PRELIMINARY DESIGN REPORT

Engineering Services for the Capital Line South LRT Extension (Century Park to Ellerslie Road)

Blackmud Creek Crossing - Environmental Impact Assessment

Rev. 2

Figure 1-1
 Project Location

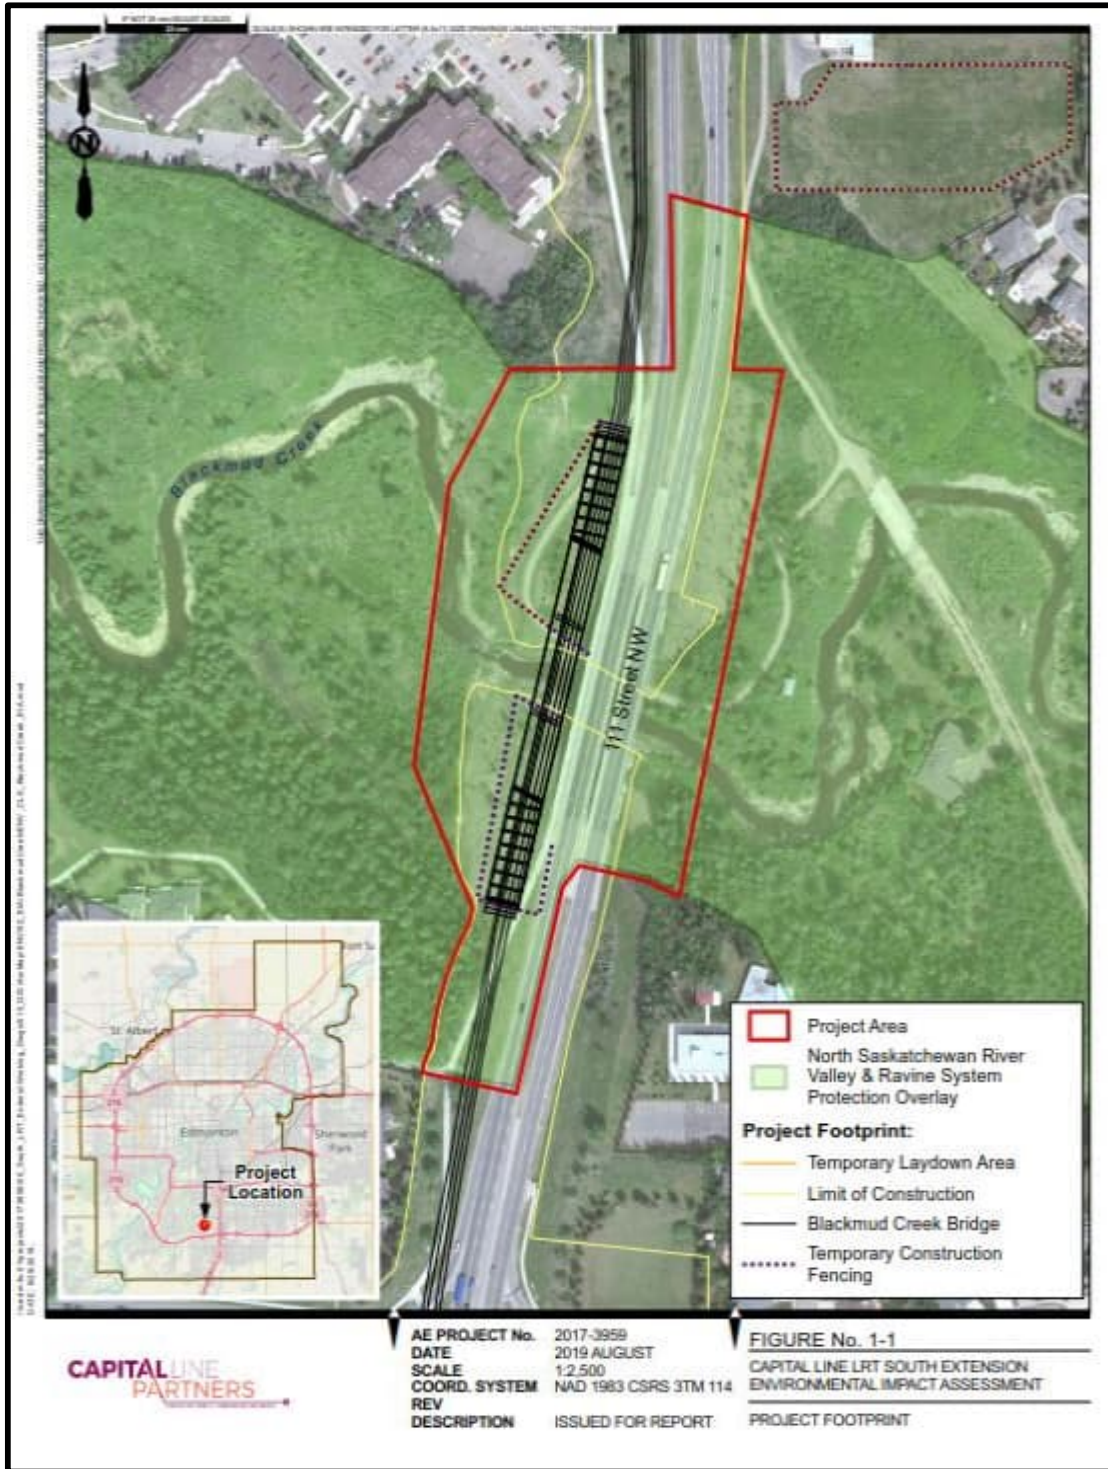
Figure 1-1 shows proposed wildlife fencing. Section 1.4.5, 1.4.6, Table 4-7, under Land Use and zoning and Wildlife movement and corridors updated to state that fencing plans will be developed with input from a wildlife specialist.

33	1.4.6, Figure 1-1	Project area is very wide on the western and eastern side - is this really needed? ○ What is the area of construction impact? I see "Project Footprint" mentioned in text, but I do not see if mapped on a figure. ○ Similarly, where are the lay down areas? They should be outside of the NSRV ARP, but this report states "Locations for lay down areas will be submitted to the City prior to	Complete Figure 1-1 updated. Section 1.4.6 updated.

Network and Assembly, Urban Growth and Open Space Strategy)	<ul style="list-style-type: none"> o The four high-use wildlife trails that were identified in the project area o The wildlife trails that are to remain open during construction. And a discussion on if the 1:5 year HWL provides enough space for wildlife movement through the construction site? o Map of proposed future MUT alignment that can further reduce its influence on the identified areas of highest risk of conflict o Proposed vegetation protection fencing 	<p>The high use wildlife trails are shown on Figure 2-2 in the top right-hand corner and called Wildlife Corridors.</p> <p>Text added to Table 4-7 under Wildlife and movement corridors to address the wildlife trails and limit of construction set above the 1:5 HWL during construction.</p> <p>Text in Table 4-7 under vegetation addresses fencing requirements.</p>
7	City Planning (Open Space Network and Assembly, Urban Growth and Open Space Strategy)	<p>We note that an amphibian survey has not been completed. Given that in-stream work is not being proposed, this may be acceptable. However, please address the need for appropriate construction buffer width and other mitigation measures in order to protect riparian habitat where amphibian species are likely to occur.</p>	<p>Complete</p> <p>Wording has been added to Table 4-7 under Wildlife and movement corridors. Wording throughout report has changed to clarify that limit of construction will be placed above the 1:5 HWL and Figure 1-1 has been updated to show the boundary.</p>

Figure 2-2
 Environmental Sensitivities Map

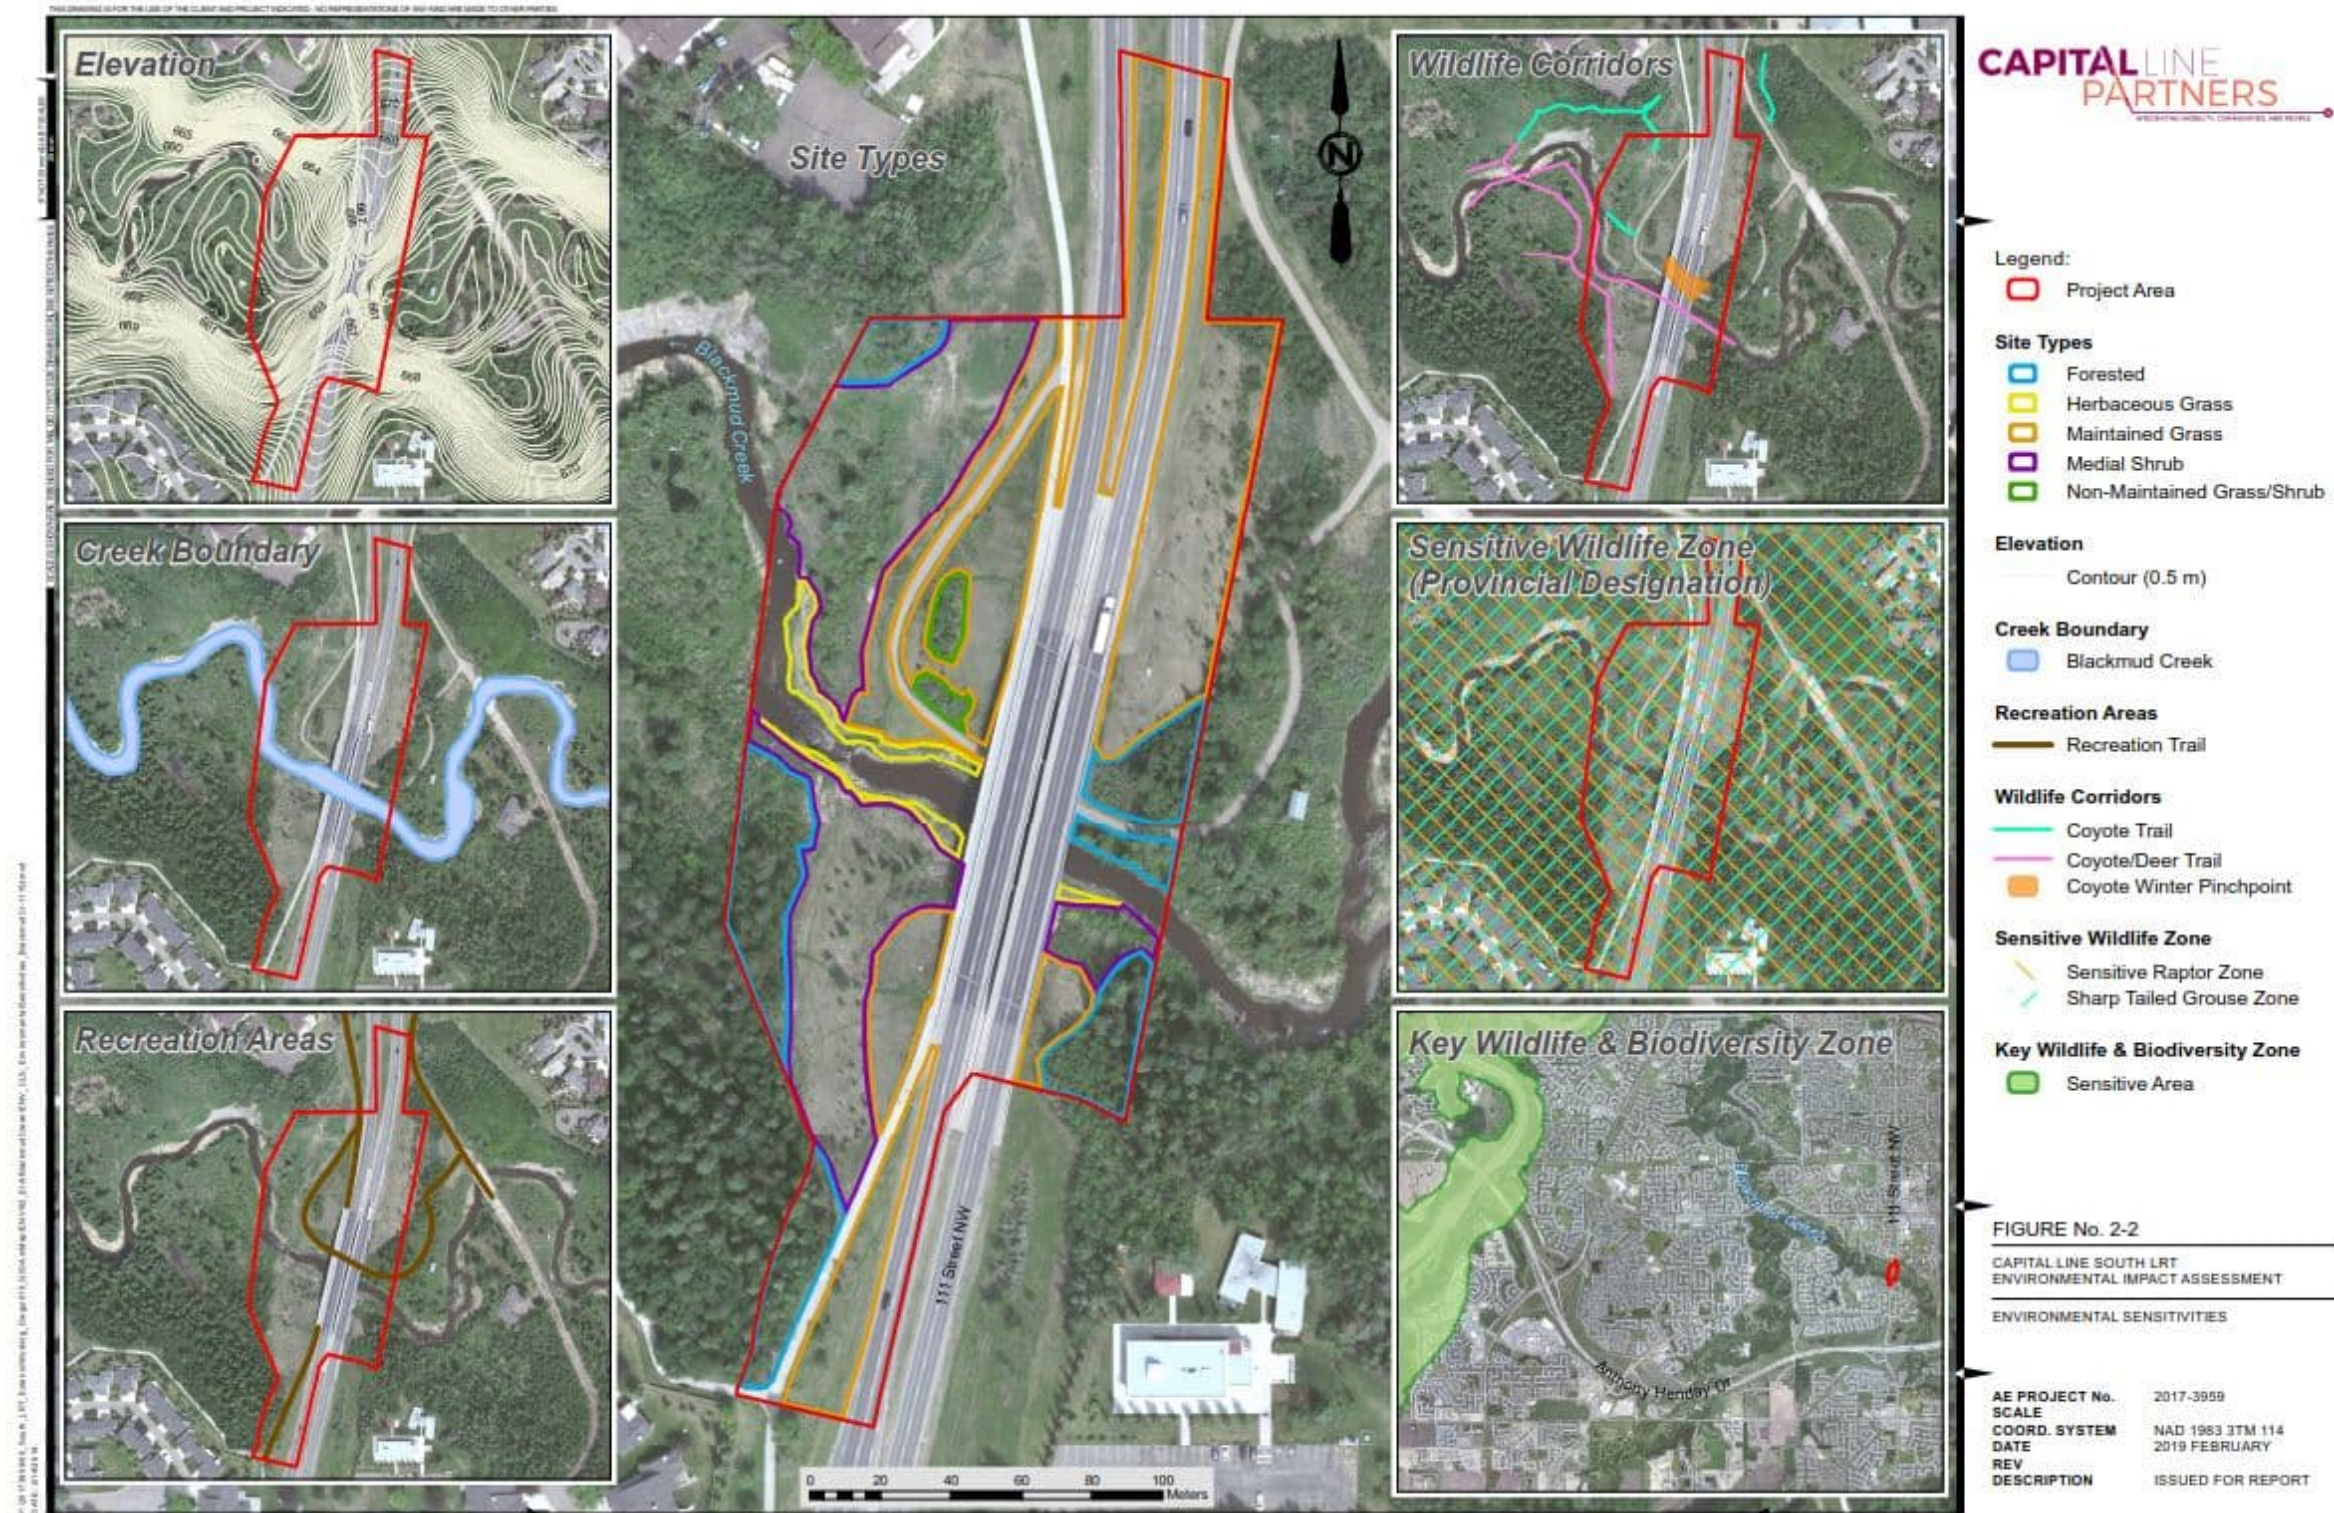
Date	No.	Section	Comment/Question/Clarification Requested by the City of Edmonton	AE Response and Revision in Final Restoration Plan
				Addressed in Section 1.4.5 and Table 4-7 Land Use and Zoning,
	24	Figure 2-2	Detailed map showing biophysical, wildlife, recreational areas in the project area was not provided	Complete Figure 2-2 updated.
	25	Table 4-7	VEC and Impact analysis on matrix based off various states of project was not provided (e.g. site preparation, demolition, bridge and MUT construction, reclamation, operation etc.)	Complete Table 4-7 updated.
	26	2.2.1, 4.1.2.1, Table 4-2, Table 4-7	Residential impact analysis was not provided in detailed for various criteria e.g. recreational, environmental, wildlife, vegetation, visual , geomorphology, hydrology etc.	Complete. Sections 2.2.1 and 4.1.2.1 updated. Table 4-7 updated.
	27	Table 4-8	List of deliverables required by LRT and applicable for the contractor should be developed to demonstrate adequate consideration and effective control of potential impact (Include construction plan with clear expectation)	Complete. Table 4-8 updated.

Date	No.	Section	Comment/Question/Clarification Requested by the City of Edmonton	AE Response and Revision in Final Restoration Plan
			construction. Previously disturbed areas surrounding the existing bridges will be used to the extent possible." Lay down areas must be outlined	
	34	1.1	Incorrect references to Bylaw 7188 (says 2014 on page 3) and Parks and Biodiversity office	Complete Section 1.1 updated.
	35	Figure 2-2, Table 3-1	<p>The following statement is a huge concern to me: "Project-specific activities associated with site preparation, construction, and landscaping have not yet been confirmed as the project is currently in the Preliminary Design Phase."</p> <ul style="list-style-type: none"> ○ Best to follow up with Suzanne on how this was dealt with in the other LRT EIA ○ Note on page 35: Landscaping should not be limited to the Design and Construction standards. Areas should be restored and plantings should incorporate wildlife passage design as outlined in the WPEDG ○ Species selected for landscaping/restoration activities should be limited to native plants seen in the immediate area. ○ It would be good to have a weed management section ○ Figure 2-2 outlines Site Types NOT "Vegetation Communities" 	<p>Complete</p> <p>Section 3 updated and Table 3-1 updated to describe activities. Table 3-1 updated.</p> <p>Table 3-1 updated. Table 4-7 under vegetation updated.</p> <p>Weed management addressed in Table 4-7 under vegetation. Figure 2-2 edited to say site type and not vegetation community.</p>
